Service Bulletin

No.: MZ09-003

Model: SR4001, SR4002, SR4003, SR5001, SR5002, CD5003

Subject: Correction of the Service Manual, electrical parts list.

REGULATOR PWB of SR4001, SR4002, SR4003, SR5001, SR5002

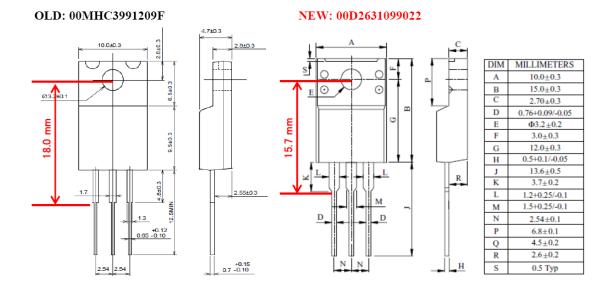
Symptom: The REGULATOR (IC) part number mentioned on the Service

Manual is not correct.

OLD NEW	POS. NO.	VERS. COLOR	PART NO. (MZ)	PART NAME	DESCRIPTION
OLD	IC87		00MHC3991209F	IC	KIA7912PI Factory cord: HVIKIA7912PI
NEW	IC87		00D2631099022	IC	KIA7912PI-U/P Factory cord: HVIKIA7912PI

The difference of package dimensions between 00MHC3991209F and 00D2631099022.

Solution: Service manual correction.
